To: Planning Committee **Date:** March 23, 2011
From: Brian J. Jackson, MCIP **File:** RZ 09-506908
 Director of Development
Re: **Application by W.T. Leung Architects Inc. for Rezoning at 6331 and 6351 Cooney Road from Downtown Commercial (CDT1) and Low Density Townhouses (RTL1) to High Rise Apartment (ZHR8) - Brighthouse Village (City Centre)**

Level 4 - Amenity Landscape Plan

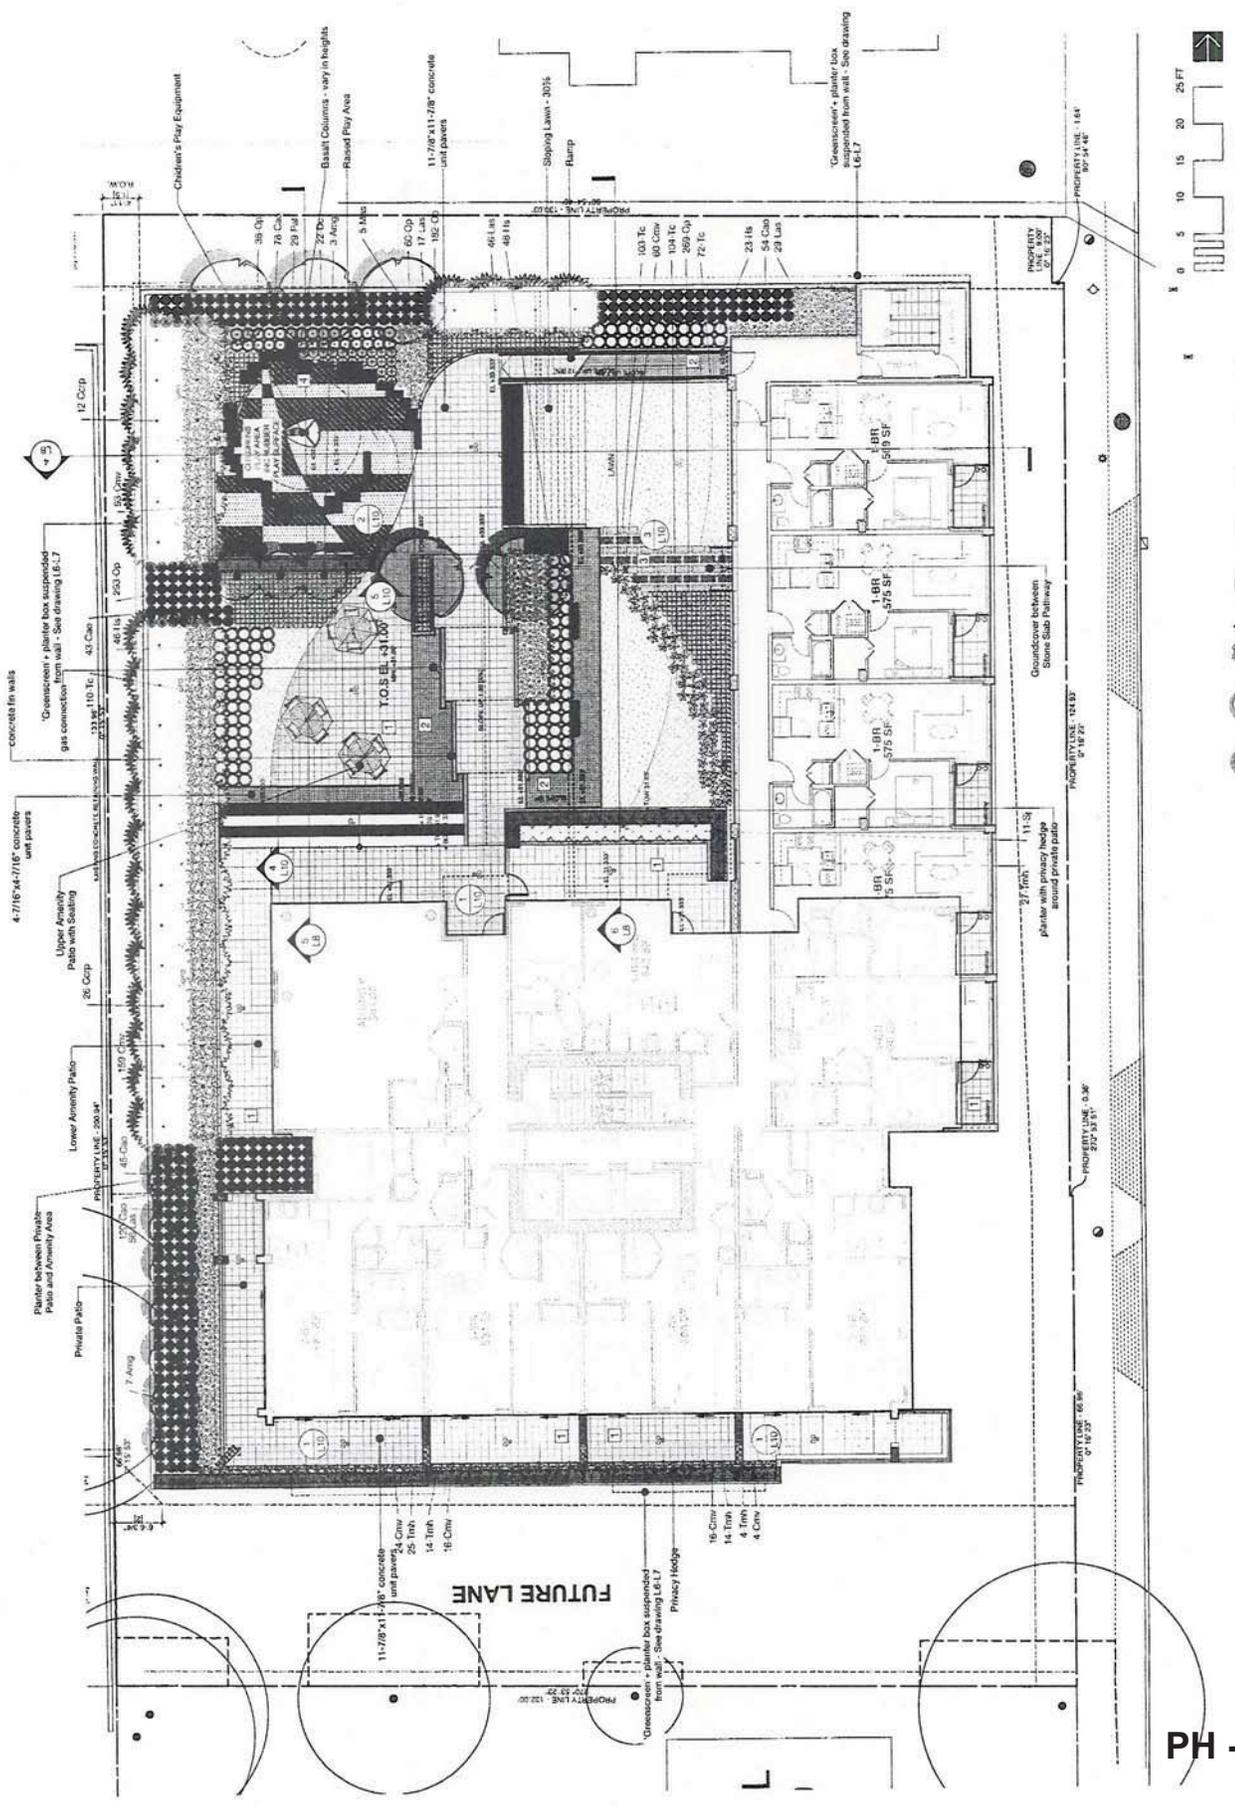
3. Consider strengthening the design of the play area surrounding the play equipment. *Applicant Response: The children's play area has been refined to provide additional detailing, denser landscape planting and creative play opportunities.*

6. Consider livability of 4th level south edge south-facing units with regard to deep decks and raised planter conditions. *Applicant Response: The raised parapet provides a noise buffer to the vehicles in the lane. As the units are south facing, more direct sunlight will penetrate into the unit. The balconies will provide sun-shading during summer months.*

7. Consider opportunities to switch the location of the north-facing one-bedroom unit and amenity space to provide west lighting into apartment unit. *Applicant Response: After careful consideration this would reduce the size of the amenity space to 59.6m² (642 ft²) and this was considered inadequate for a development of this size.*

1 East Elevation
Scale: 1/8" = 1'-0"

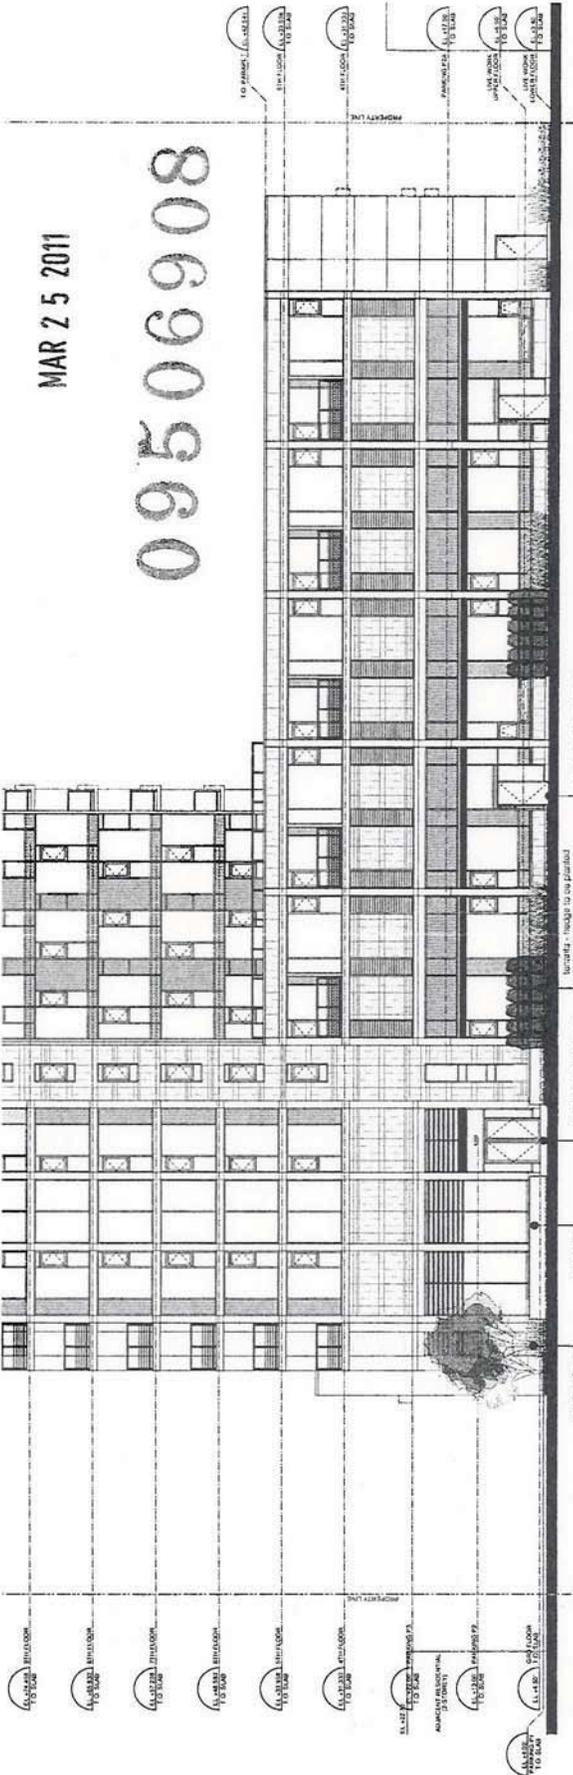
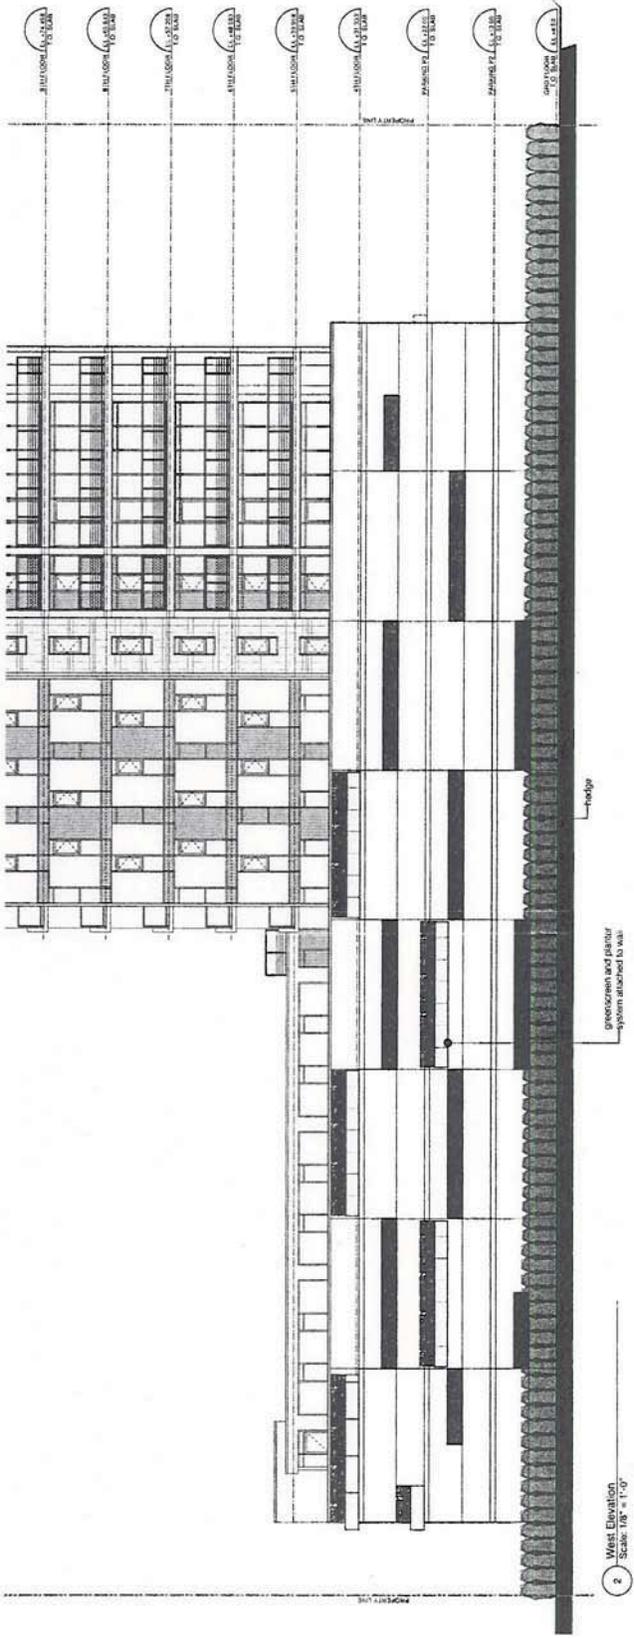
1. Design development to provide screening for rooftop mechanical equipment. *Applicant Response: Rooftop mechanical equipment is screened by the raised brick masonry parapets between grid lines 3 and 4.*

2. Design development to improve south side elevation and consider paving materials on the lane, lighting and screening along the south property line. *Applicant Response: A suspended planter was added over the parkade entrance. A 1.5m wide sidewalk has been incorporated within the lane including City Centre standard post top lighting in the laneway plus wall mounted lights along the face of the building. The detailed lane design to ensure preservation of the 6 existing trees along the adjacent property to the south (6371 Cooney Road) will be resolved at Development Permit to the satisfaction of the Directors of Engineering and Transportation.*
